City of Portland, Maine – Building or Use Permit Application 389 Congress Street, 04101, Tel: (207) 874-8703, FAX: 874-8716

BUILDING PERMIT REPORT
Ľ	ATE: 29 OCT. 99 ADDRESS: 135 Vaughan ST. CBL: 062-A-009
F	REASON FOR PERMIT: 2nd Floor of Carriage house To rooming Unit (No Kitchen)
æ	UILDINGOWNER: MargoT McWilliams
P	ERMIT APPLICANT: ICONTRACTOR ON BONG ON CONTRACTOR
_	se group: <u>R-3</u> construction type: <u>B-B</u> construction cost: <u>37,060</u> permit fees: <u>2%,00</u> hothout Kitchen
	he City's Adopted Building Code (The BOCA National Building code/1996 with City Amendments) he City's Adopted Mechanical Code (The BOCA National Mechanical Code/1993)
	CONDITION(S) OF APPROVAL
Т 	his permit is being issued with the understanding that the following conditions are met: $\frac{*}{8}$ $\frac{8}{7}$ $\frac{9}{11}$ $\frac{12}{12}$ $\frac{13}{12}$ $\frac{14}{15}$ $\frac{17}{12}$ $\frac{12}{7}$ $\frac{13}{7}$ $\frac{34}{32}$ $\frac{34}{36}$ $\frac{43}{7}$ $\frac{43}{7}$
<u>1</u> 1. 2.	Before concrete for foundation is placed, approvals from the Development Review Coordinator and Inspection Services must be obtained. (A

MCWILLIAMS CARRIAGE HOUSE REVISED LOFT FLOOR PLAN SCALE : 1/4"

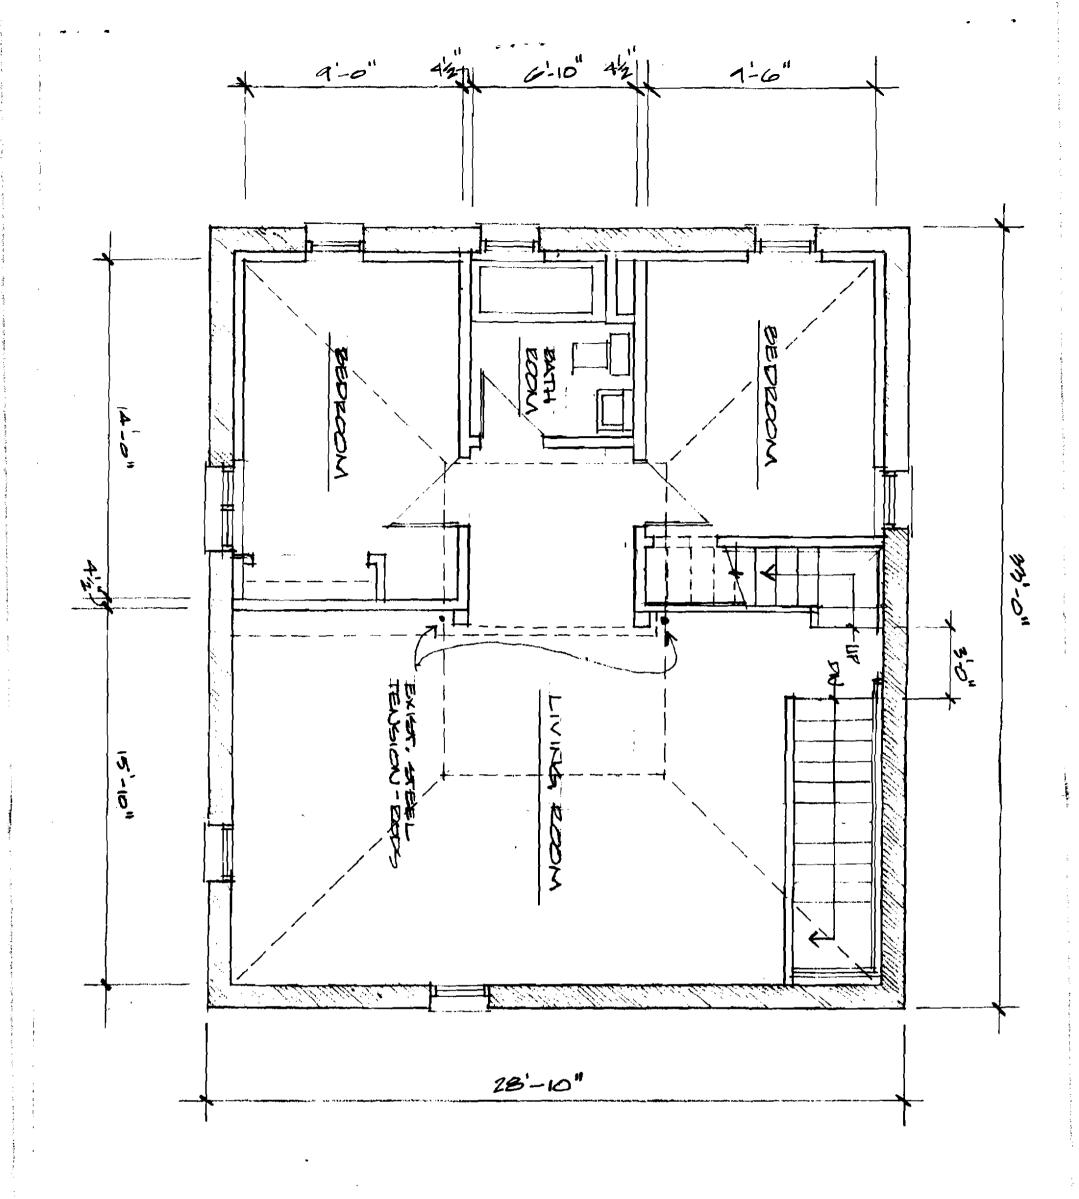
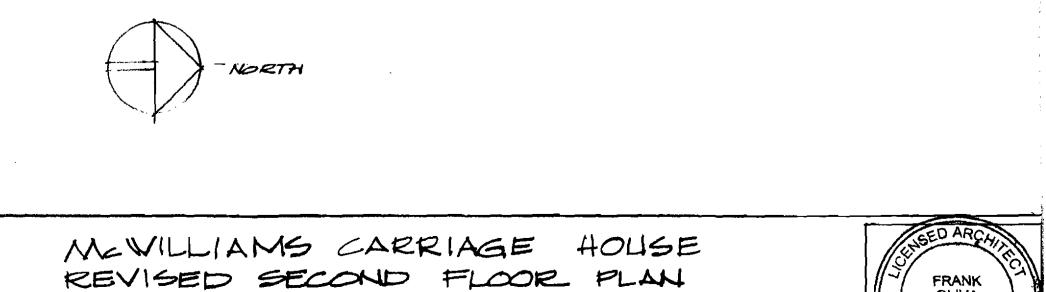
The result of this effort has been a slight shortfall, (9 1/2" tread length), to the stair leading from the ground floor up to the second floor living space. The stair leading from the second floor living space up to a loft space was also impinged, allowing a 2'-4" tread width. The McWilliams Family is well aware of these conditions, as they have been participants in the construction effort. They have stated, in a letter that is attached to this letter, that they will assume liability for any accident that may occur due to the stair configurations.
